From: Pennington, Blake
Sent: Tuesday, September 21, 2021 1:03 PM
To: Paxton, Kara
Cc: CityClerk; Curth, Jonathan; Williams, Kit; Bunch, Sarah
Subject: RE: will you submit our appeal of the approval of LSIP to the city council?

MEETING OF OCTOBER 19, 2021

Re: Large Site Improvement Plan Approval: LSIP-2021-000007 (Randal Place Development)

Appeal from Conditional Approval of Large Site Improvement Plan
Plan Number LSIP-2021-000007, Randal Place Development

Exhibit for Curb Bump outs with sidewalk and ADA connections

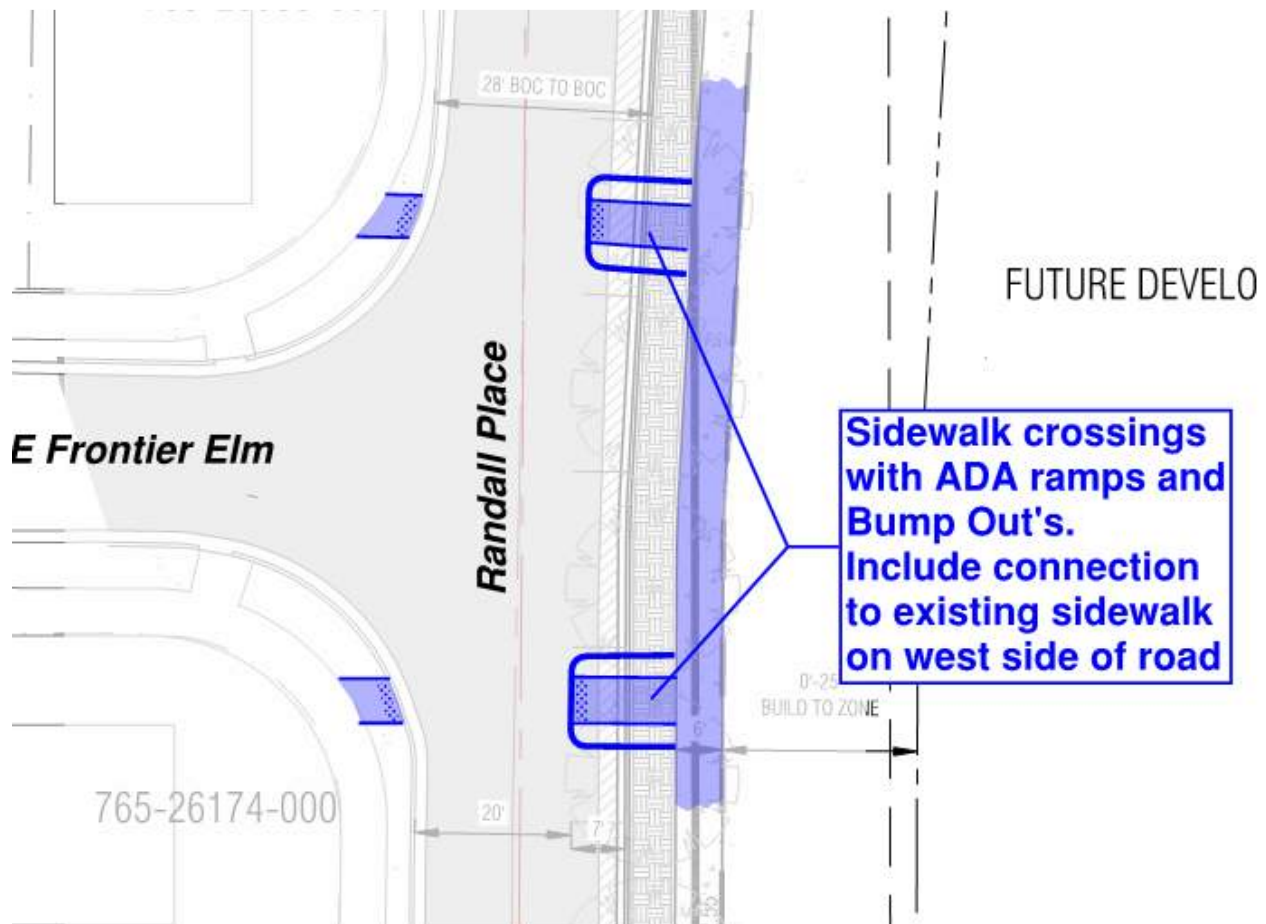
To ensure the parking does not conflict with the parking, engineering staff suggests the applicant consider adding curbed bump outs with sidewalks and ADA ramps as shown in the sketch below. With this solution, a variance is not required for parking across the top of the T intersection, and staff would recommend this request be removed from consideration, as this request is not a variance from the unified development code, and it appears after discussing with the applicant that an acceptable solution can be achieved.

Recommendation: Engineering Staff recommends this variance request be removed from consideration.

Zion Road Phase 2 – 2019 Bond Program
Project Map and Typical Sections

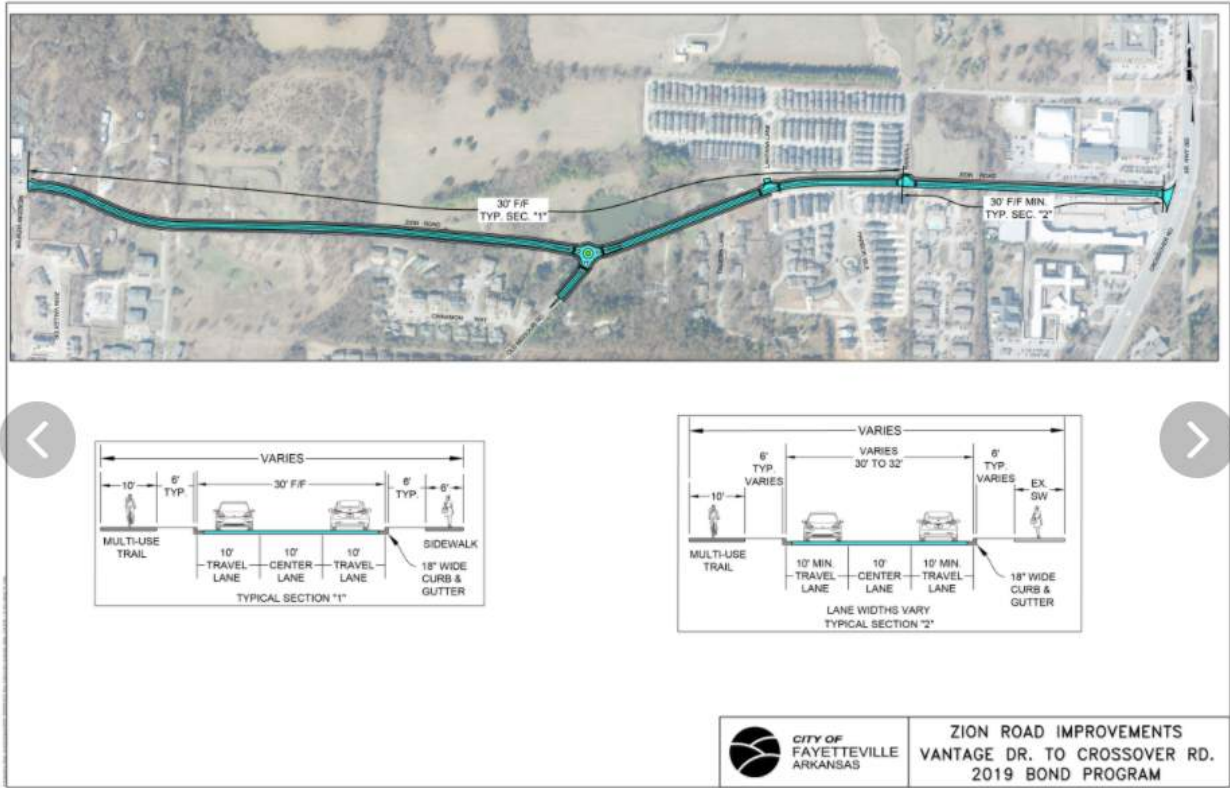
Staff Discussion: Engineering staff recognizes the importance for on street parking in a mixed use development, and is therefore in favor of providing this additional parking. However, Zion Road is currently undergoing improvements for utilities, storm drainage, multiuse trail, and widening for a turn lane. This project is part of the 2019 Bond Program, and is scheduled to be completed early 2022. Along the frontage of the Randall Place Development, Zion Road will be improved to 3 lanes of traffic, with a continuous center turn lane, and will also include a new multiuse trail along the north side of the road. The turn lane in this area was deemed necessary due to significant amounts of turning movements occurring for commercial and residential multifamily areas. These developments

generate a significant amount of left turns which cause issues with congestion due to the volume of traffic, and increased risk for rear end collisions. Therefore, city staff will not support removal of the turn lane in favor of on street parking.

In addition, engineering staff recommends an additional pedestrian crossing be provided across Zion Road in the vicinity of Valley Lake Drive to allow safe passage of pedestrians who may park on the south side of Zion, to access the development site, as experience shows many pedestrians will not walk back to Randall to cross as it is out of their way.

Recommendation: Engineering Staff recommends approval of this variance to the master street plan typical section with the following conditions:

Exhibit of On Street Parking as recommended with Conditions of Approval by Staff

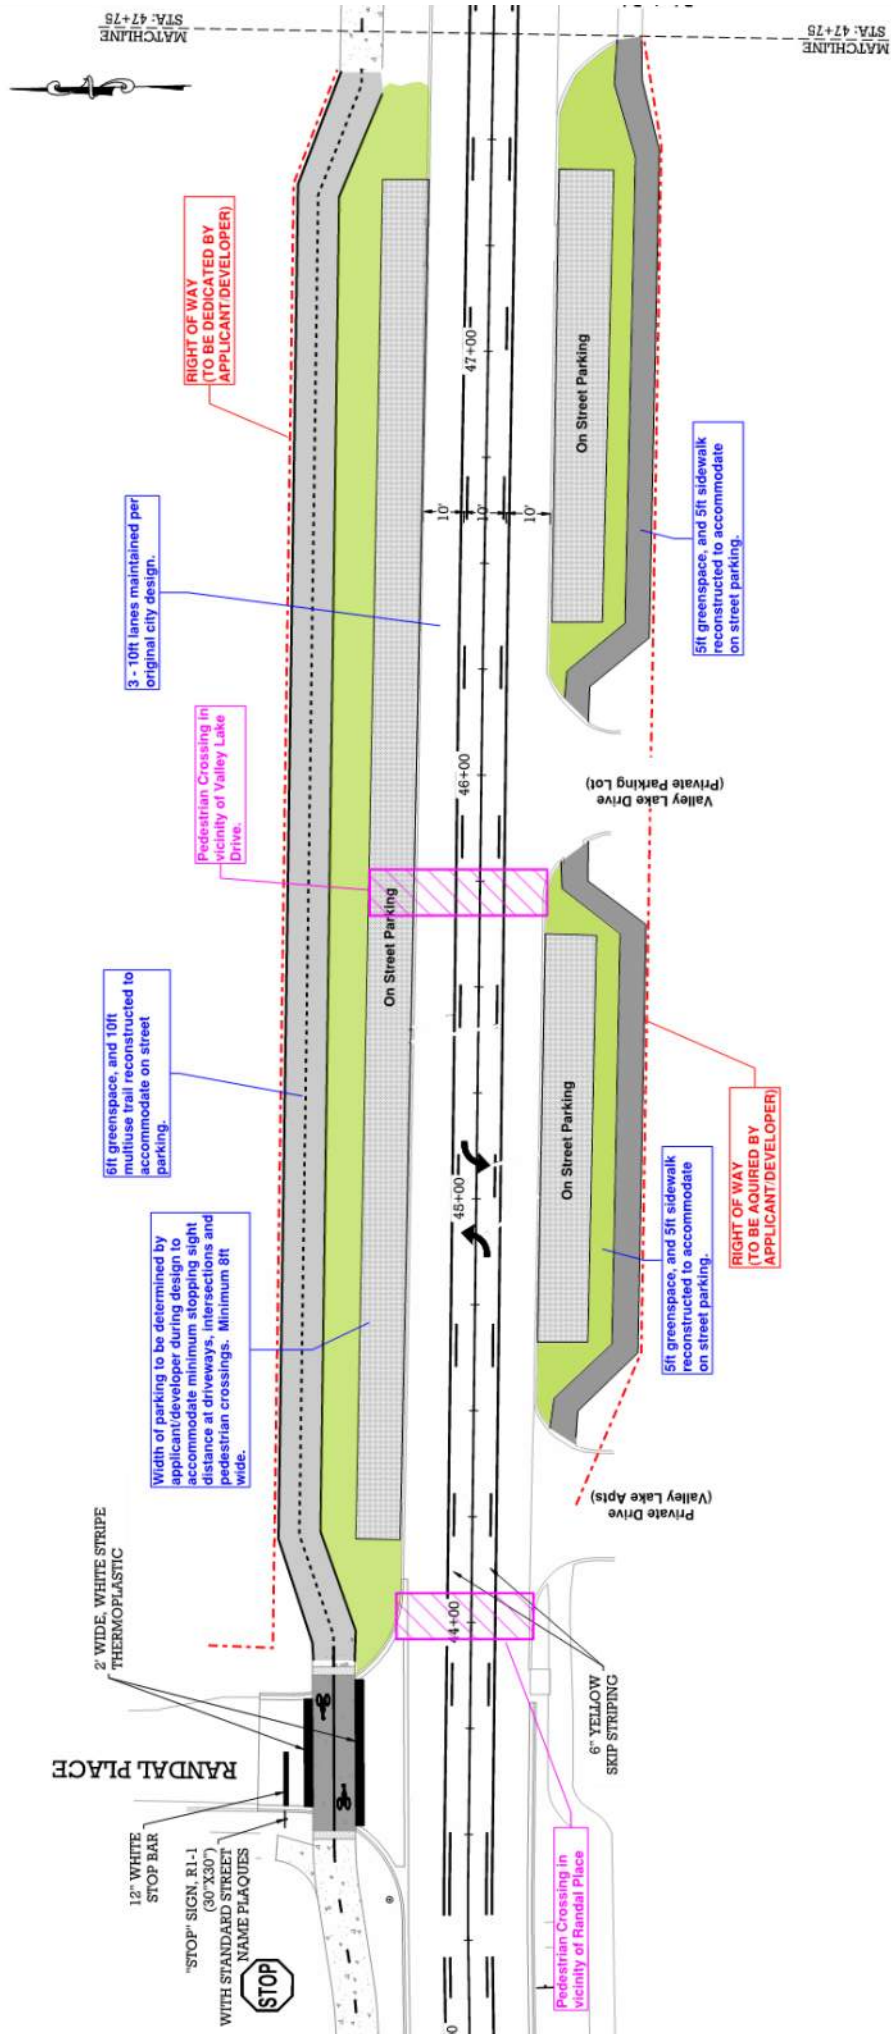
5. An additional crosswalk with signage per Minimum Street Standards is included in the vicinity of Valley Lake Drive to

On Street Parking - 54 Spaces
Off Street Parking - 96 Spaces

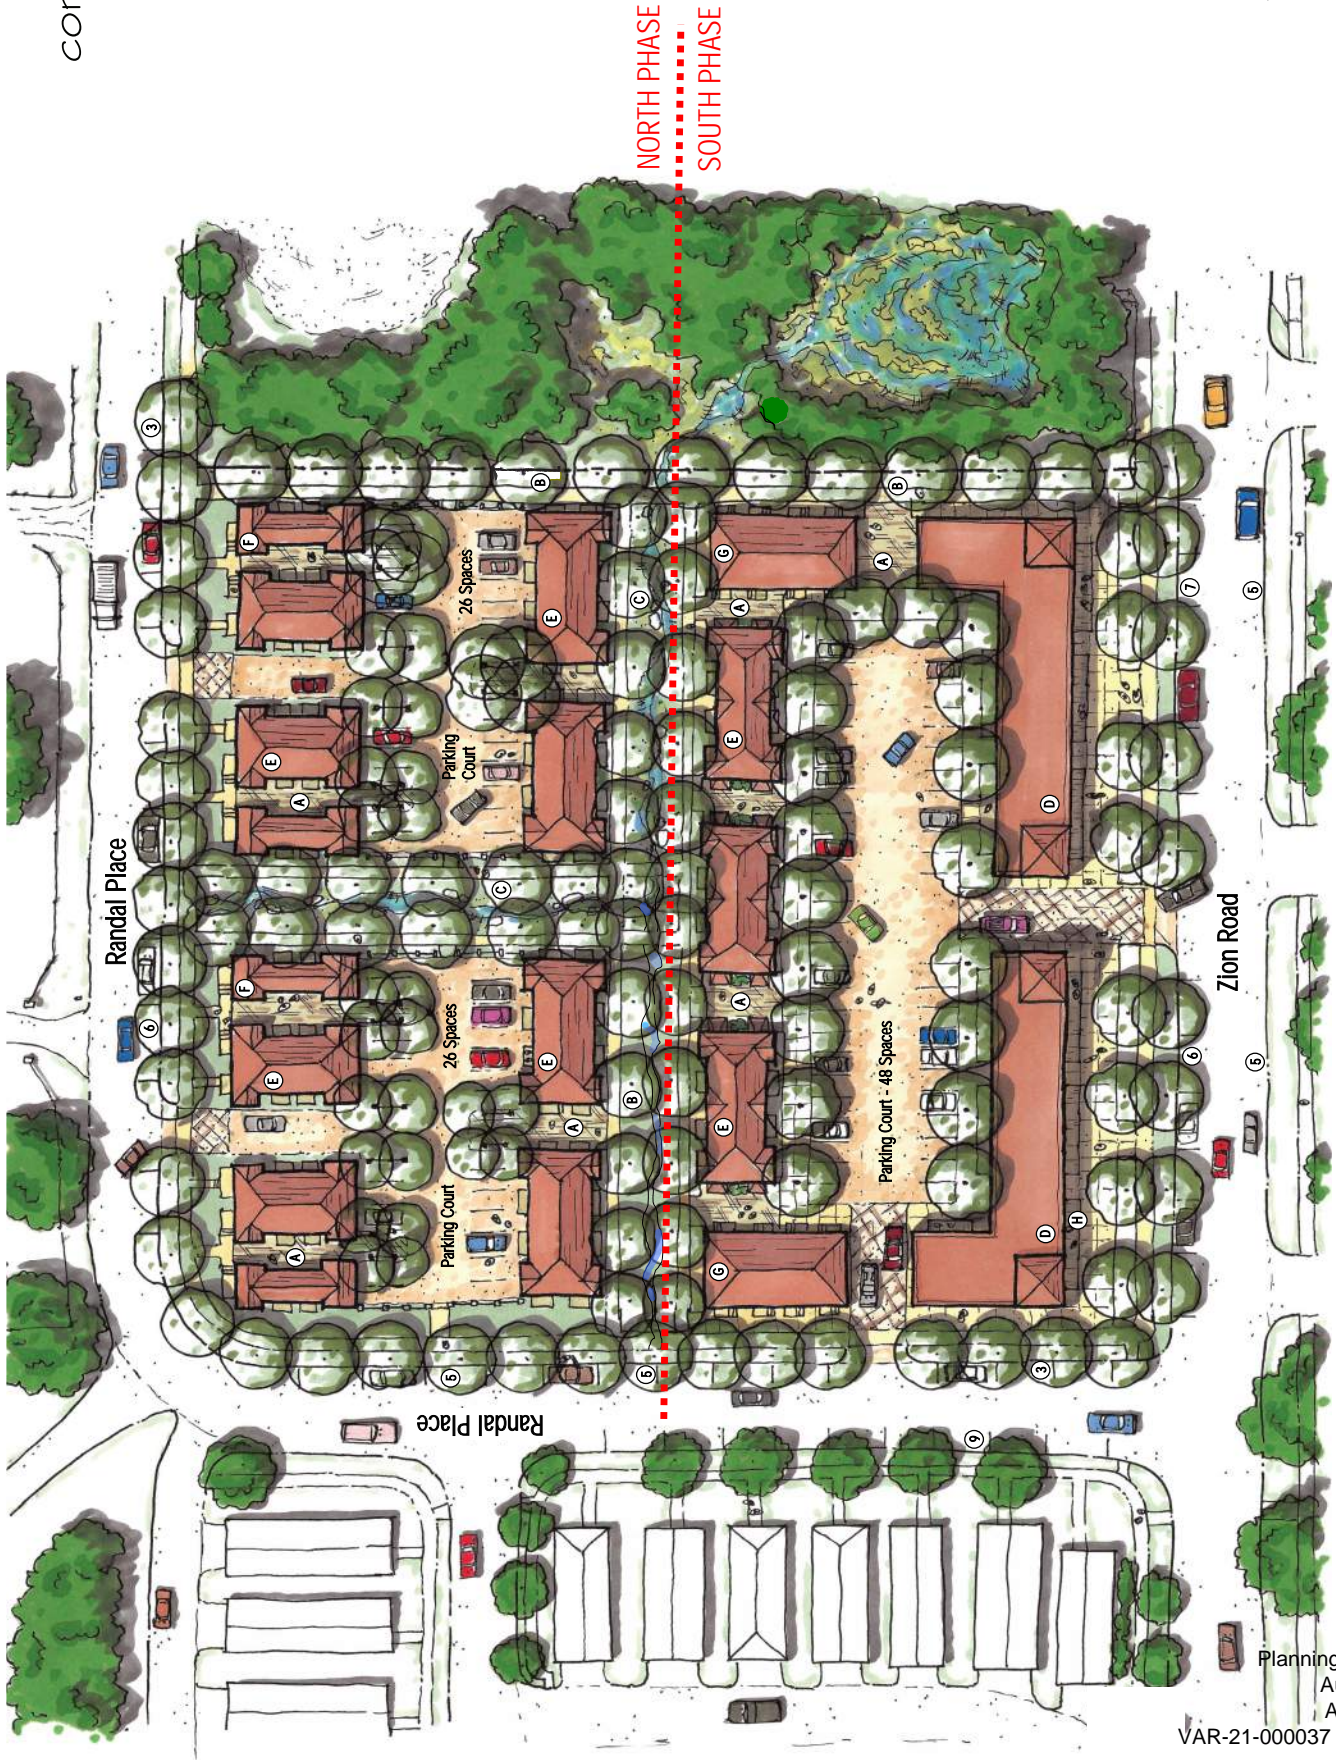
The proposed LSIP does not provide adequate parking on site to support the development’s planned uses. See Fayetteville United Development Code § 172.05. The rendering of the full site plan shows there are 48 parking spaces in the south portion of the LSIP as conditionally approved. The development review manager’s conditional approval letter notes that 69 parking spaces are required for the south half of the LSIP – 41 spaces for non-residential uses and 28 spaces for residential uses. As there are only 48 parking spaces on site, 23 required parking spaces would be on-street parallel parking spaces on Randal Place and on Zion Road.³ Accordingly, the applicant would need to meet one-third of parking requirements for the south portion of the LSIP with on-street parking. See § 172.05.

³ In the rendering of the full site plan (submitted as an Exhibit to VAR-2021-000037), the applicant indicates that 150 parking spaces will be required to support the proposed residential and commercial space, but only provides 96 parking spaces on-site.
